UD CHILLER CAPACITY UPGRADE DEPARTMENT OF VETERANS AFFAIRS PROJECT NO. 646-20-109 PITTSBURGH VA MEDICAL CENTER UNIVERSITY DRIVE CAMPUS BUILDING 8 PITTSBURGH, PA	
1 2	The project specifications list a short circuit, coordination, and arc flash analysis. Is there an existing study and SKM model available? Or do we have to remodel the entire system and evaluate all equipment?	An “Electrical Coordination and Arc Flash Study” was completed in 2023 including short circuit analysis, protective device coordination study, voltage drop analysis, and arc flash hazard analysis. There is SKM model produced from this study. The VA will make this information available to the successful bidder.
1 3	All new medium voltage lineups appear to have medium voltage fusible switches incorporated. Please advise the intent of the Medium Voltage Circuit Breaker Switchgear specification.	All new MV switchgear line-ups are fusible-switch style (spec. section 26.13.16). The MV circuit breaker specification section (26.13.13) is included in the specifications because the standard VA specifications include the medium-voltage transformer requirements in the MV circuit breaker specification section.

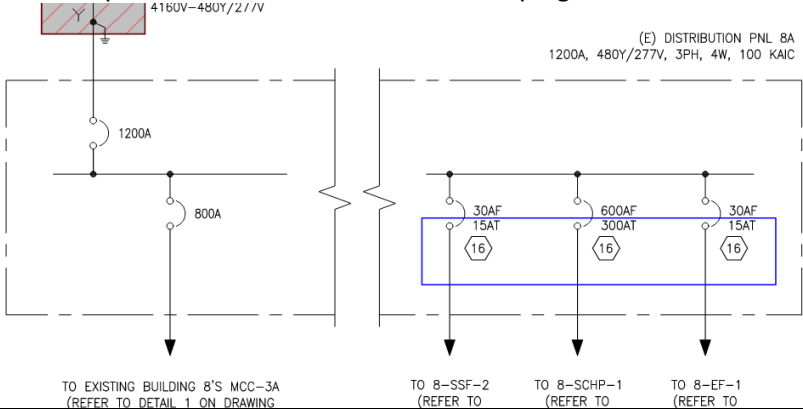
74	RFI #1 issued with amendment 4, indicates we are using black steel pipe for the new CDW pipe and connecting to the existing schedule 10 SS pipe. RFI # 65 calls for all new CDW pipe to be schedule 20 SS. Which is correct?	All new condenser water piping shall be SS schedule 20 and the valves shall be non-stainless steel.
75	Per RFI Response #65 should all valves in the condenser water system also be stainless steel? If so, could you please provide a stainless steel valve spec?	All new condenser water piping shall be SS schedule 20 and the valves shall be non-stainless steel.
76	Can you also able to provide us with the factory label (clear picture would be great) off of the existing Distribution panelboard PNL 8A to add new CB plugs?  TO EXISTING BUILDING 8'S MCC-3A (REFER TO DETAIL 1 ON DRAWING) TO 8-SSF-2 (REFER TO TO 8-SCHP-1 (REFER TO TO 8-EF-1 (REFER TO	See Below. The VA does not have any submittal records on file for this panel. This is the only information relative to the label available.
